**RE: Kennan Properties
12900 Central Ave SE
Grading and Drainage Plan
Stamp Date: 05/15/18
Hydrology File: L22D061**

Based upon the information provided in your submittal received 05/15/2018, the Grading and Drainage Plan **is not** approved for Building Permit and Grading Permit. The following comments need to be addressed for approval of the above referenced project:

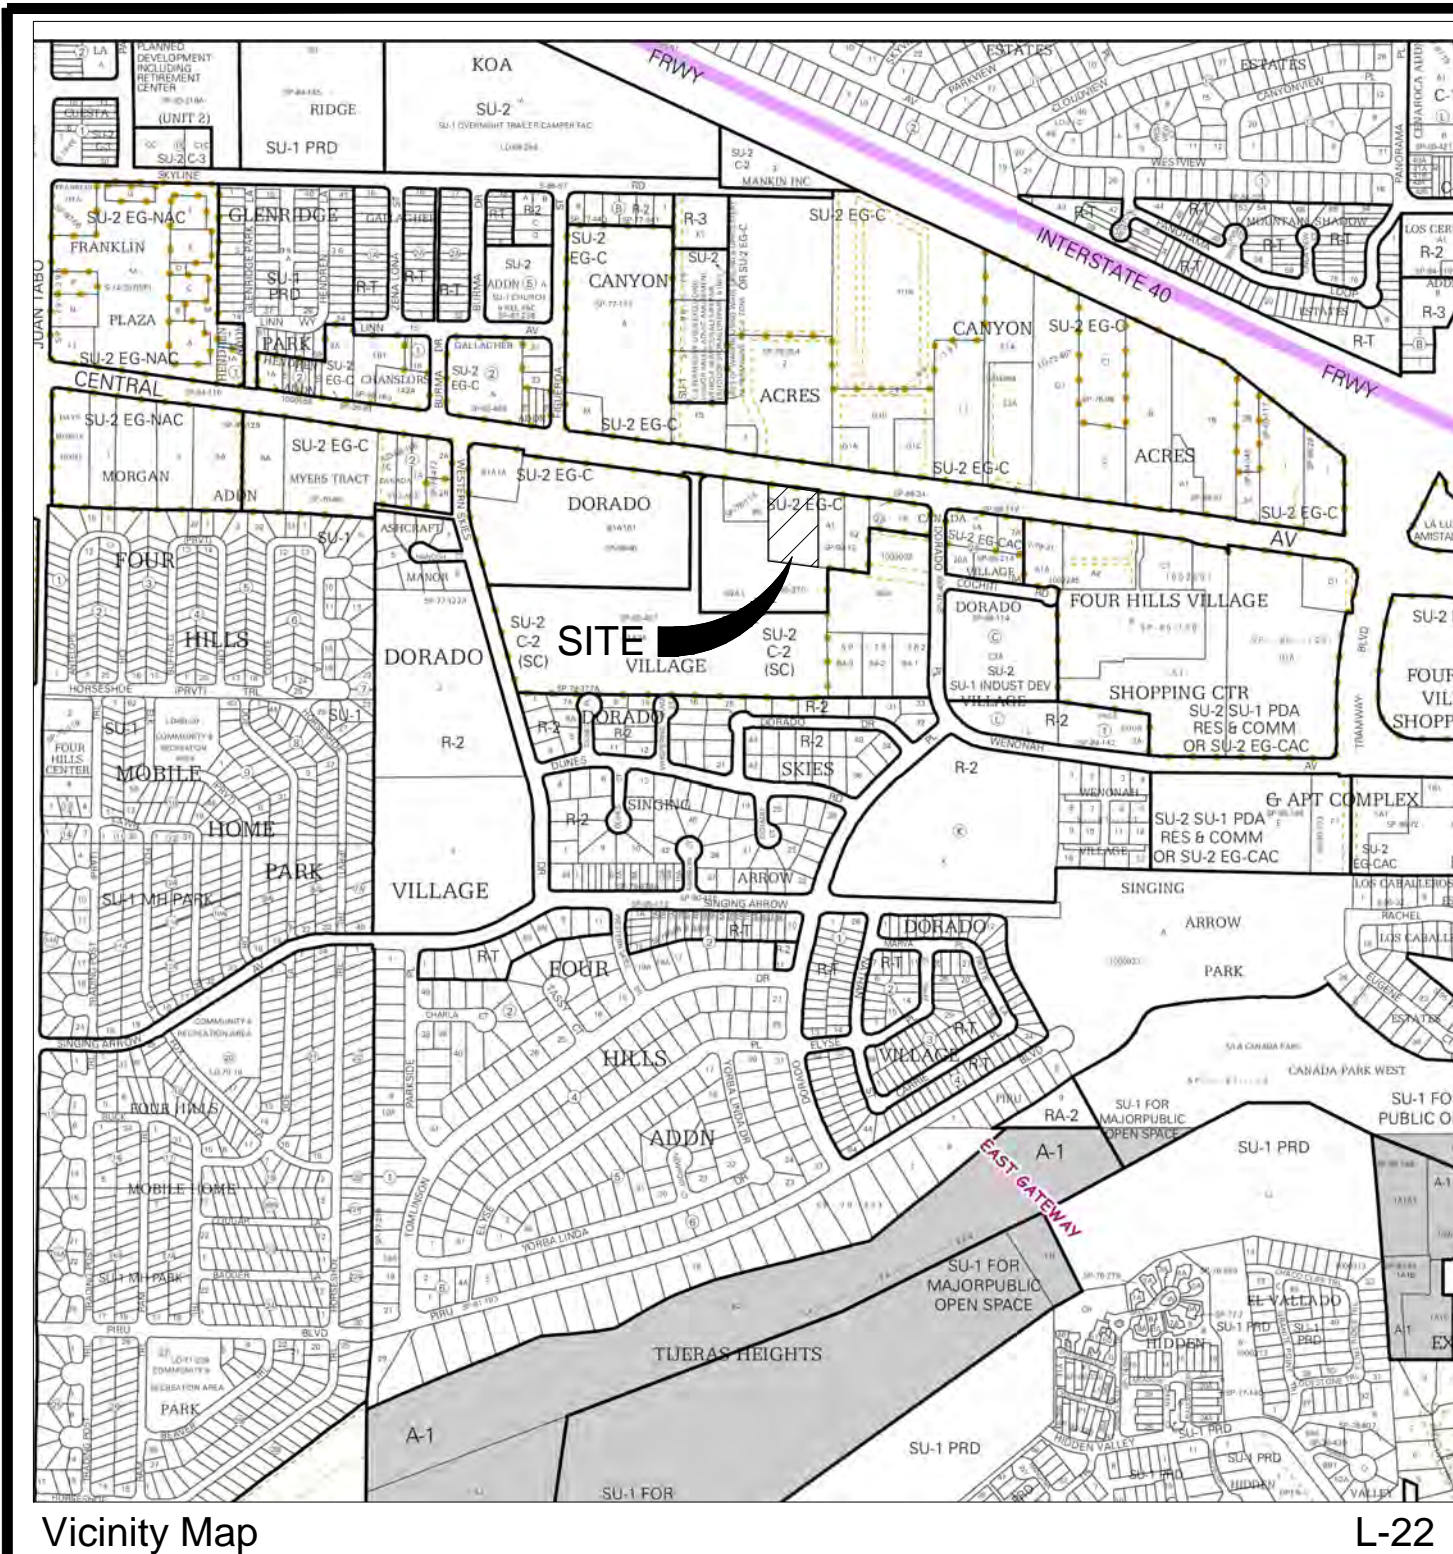
8. What is the shaded area around the northeast parking? It appears to be a carport. This carport needs to drain into the site.
9. It also appears that this area was excluded from the drainage calculations. Please add this area to the calculations.
10. How are you handling the off-site drainage? The site east of this project sheet flows from the adjacent parking area right into the proposed building which is lower than the adjacent property. (see photo)

POND RETAINING WALL

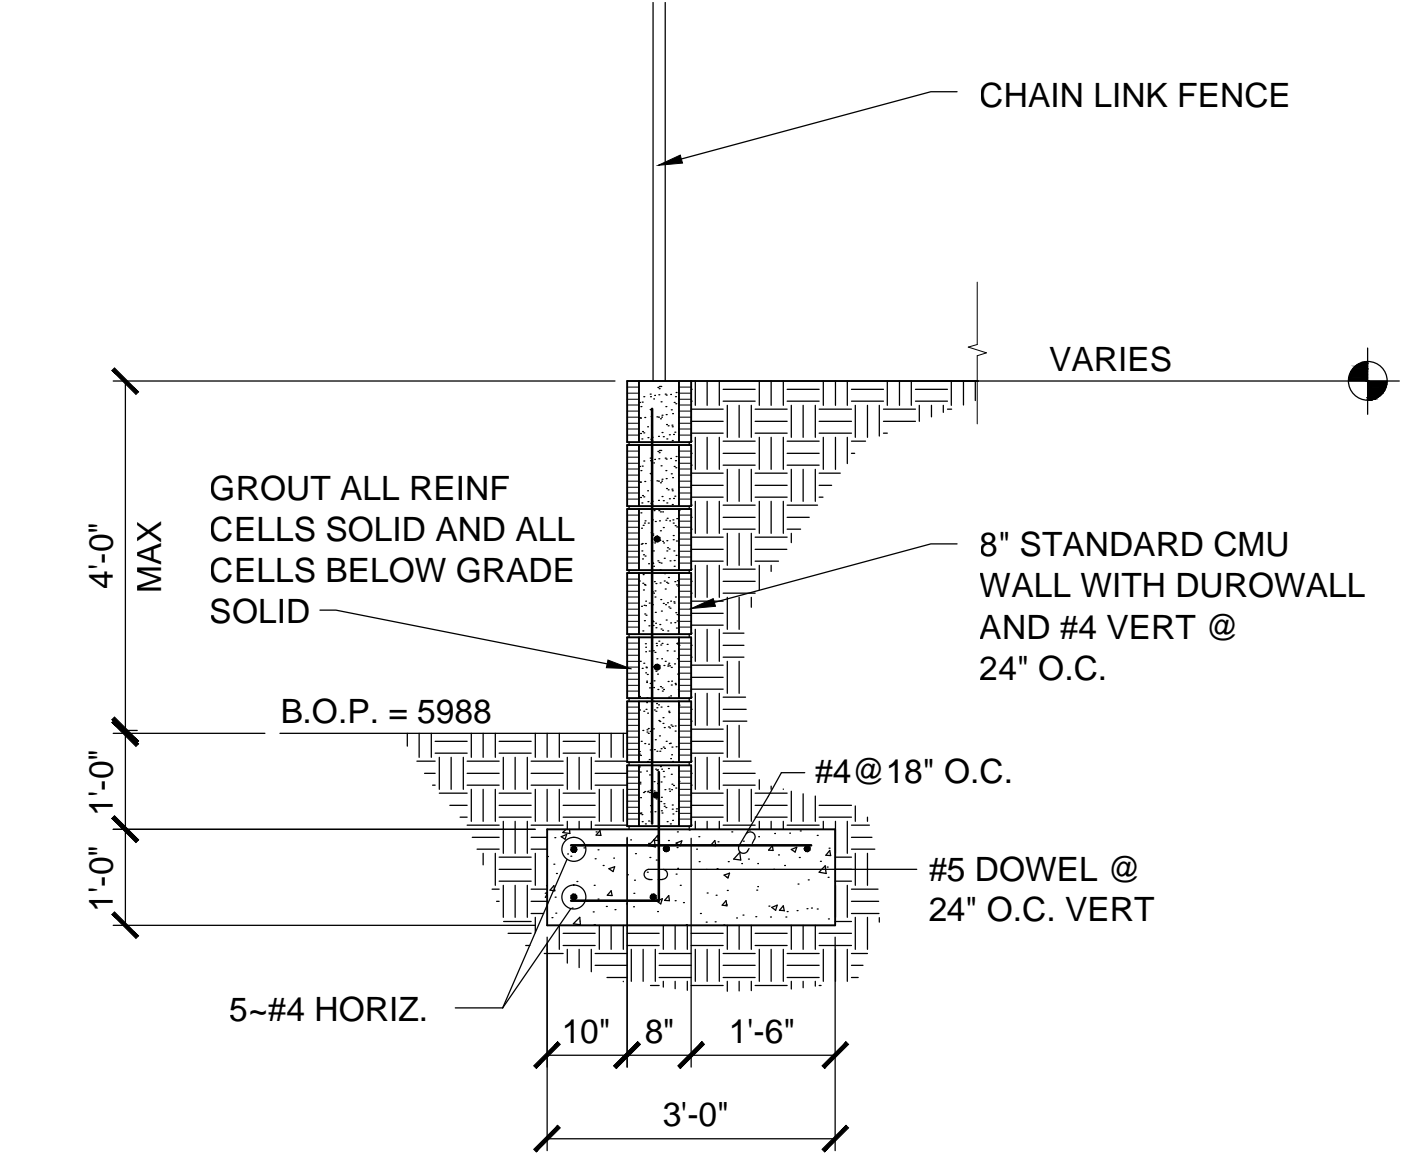
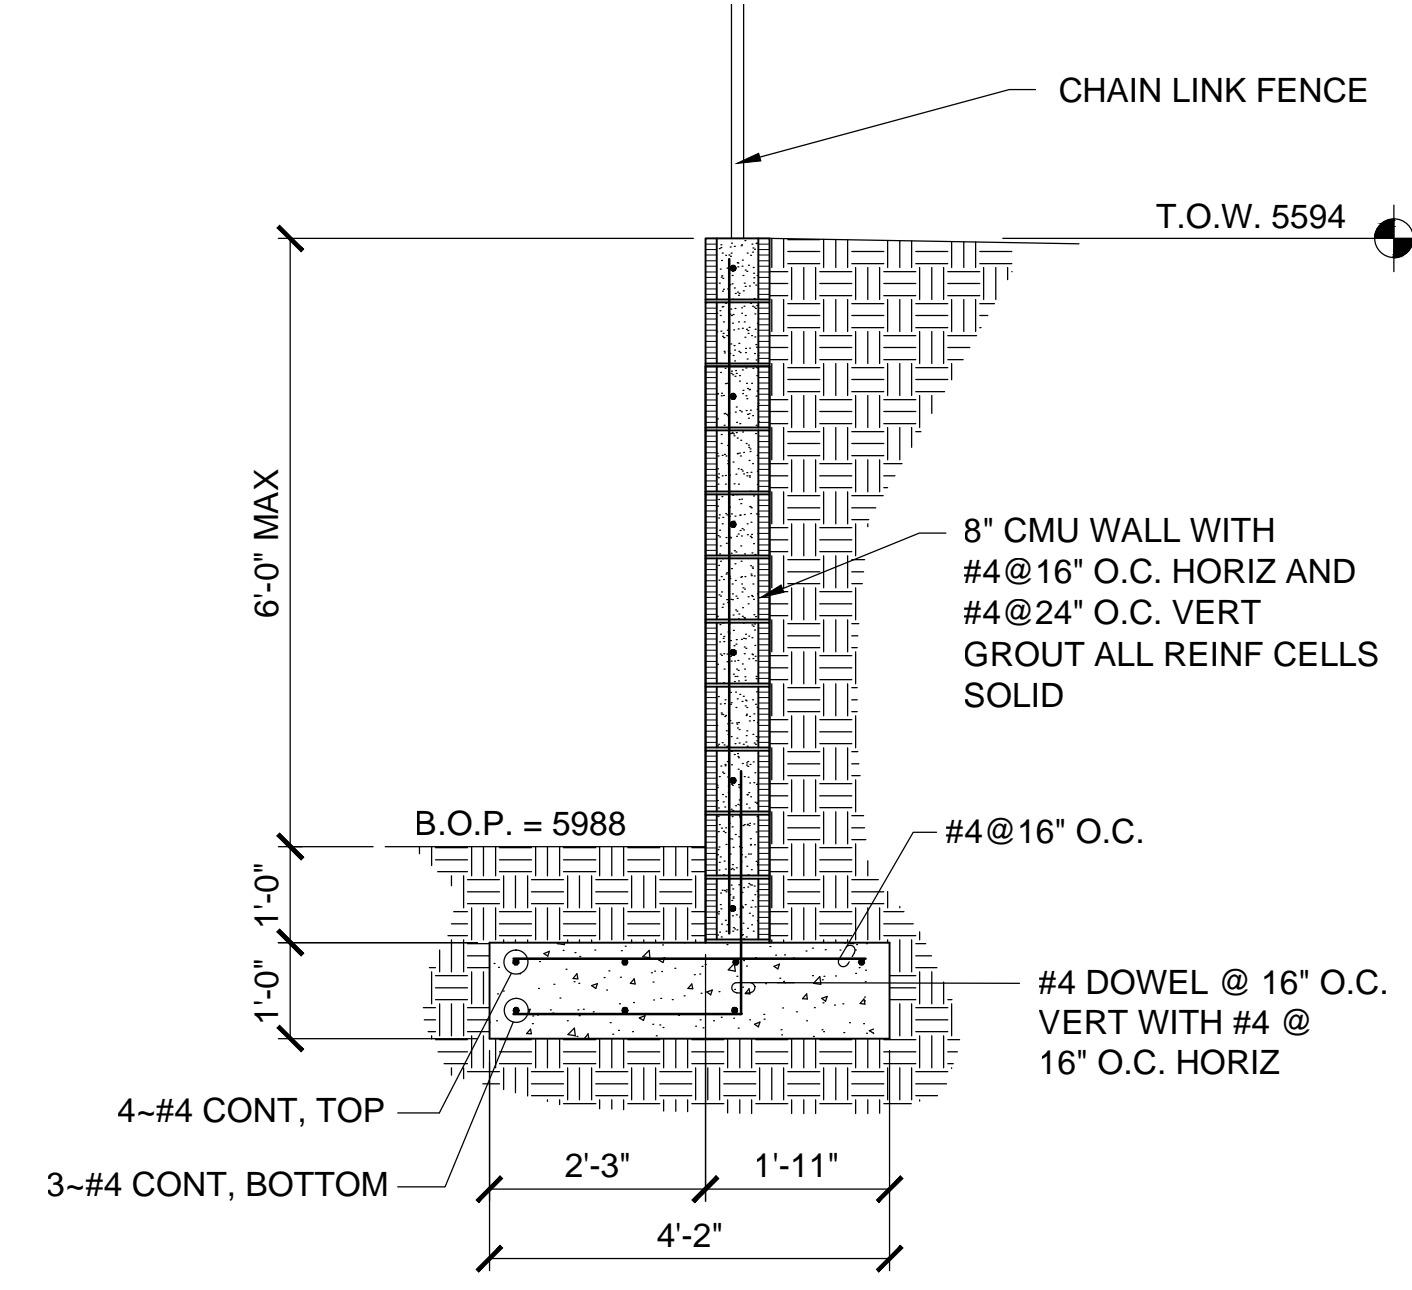
11. Please provide the first flush volume elevation and the extra runoff volume storage elevation on both Pond Retaining Wall Sections.
12. Please change the precipitation zone in the Drainage Calculations from 4 to 3.

GRADING AND DRAINAGE PLAN

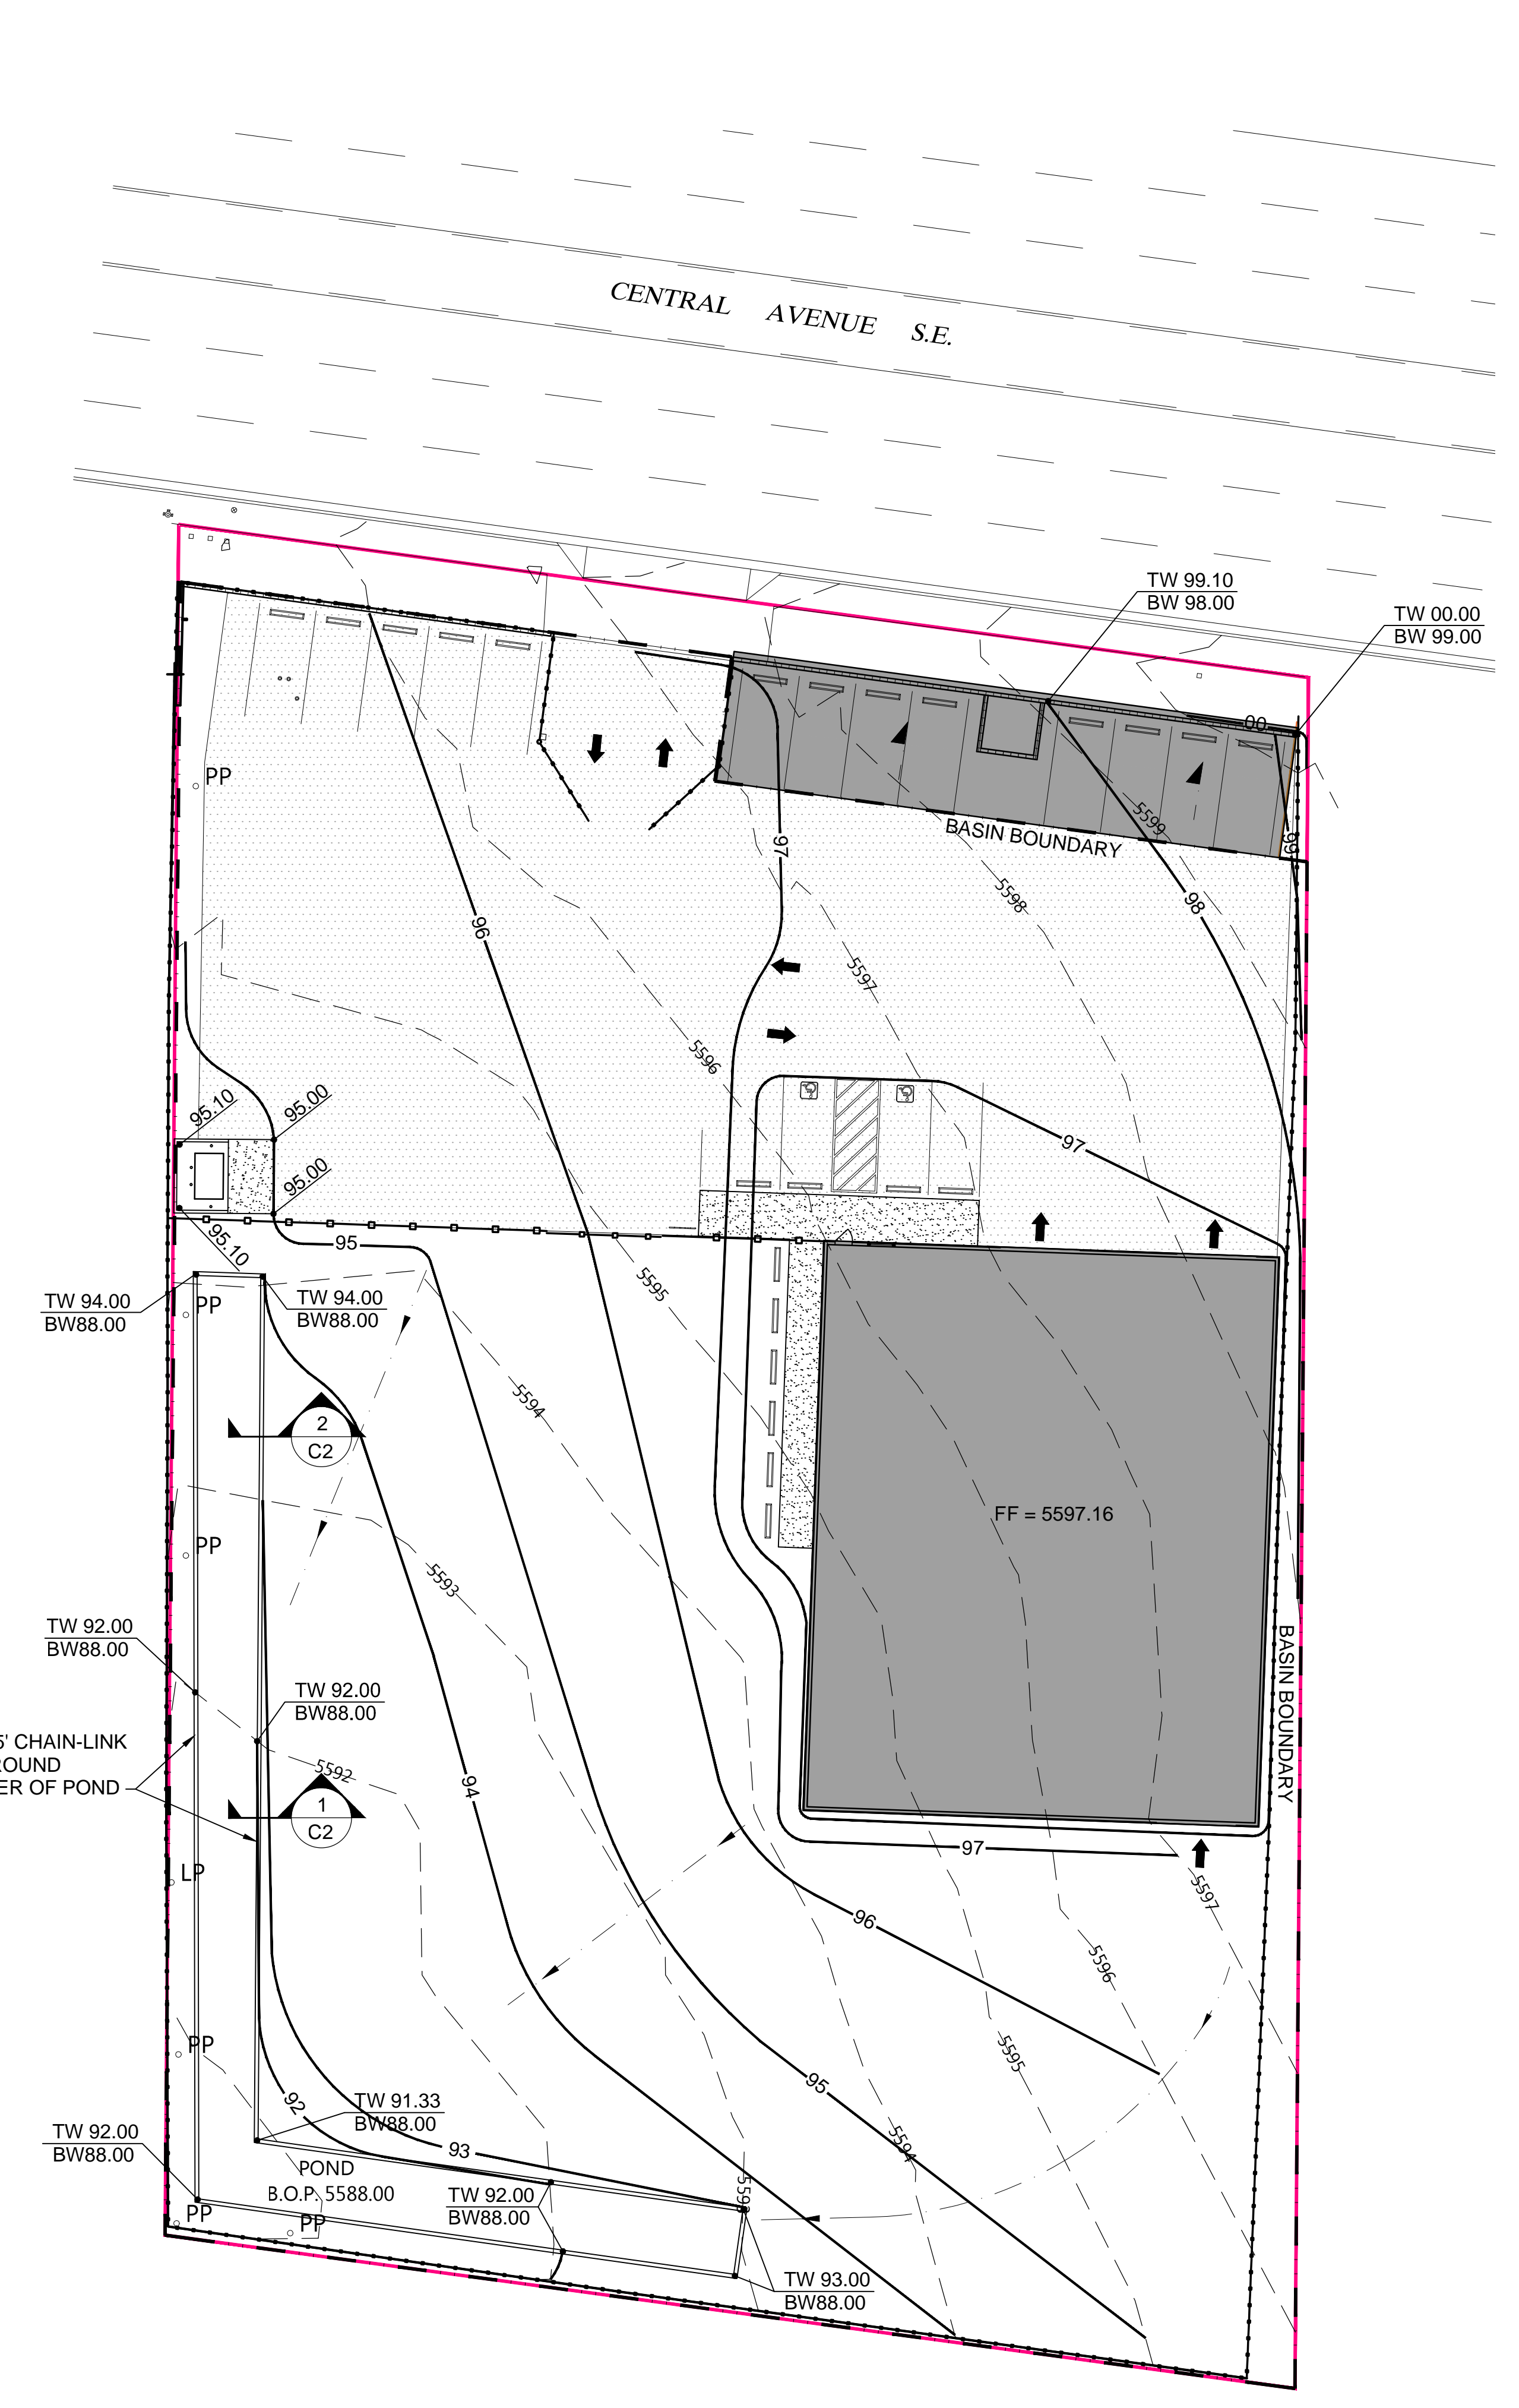
1. The site currently shows more than 1 acre of disturbance is being proposed. An Erosion and Sediment Control Plan is required and has to be submitted to the storm water quality engineer (Curtis Cherne, PE, ccherne@cabq.gov). Hydrology's approval for Grading or Building Permit will not be given until the submittal of the ESC Plan.
2. Please provide the flood plain note with effective date.
3. Please provide the benchmark information for the survey contour information provided.
4. Please provide existing flowline elevations around the existing driveway on Central.
5. Please better define the existing driveway. There appears to lines missing.
6. Please add proposed grade points at the edge of the asphalt paving and along the parking areas.
7. Please label the asphalt area and the compacted dirt area.
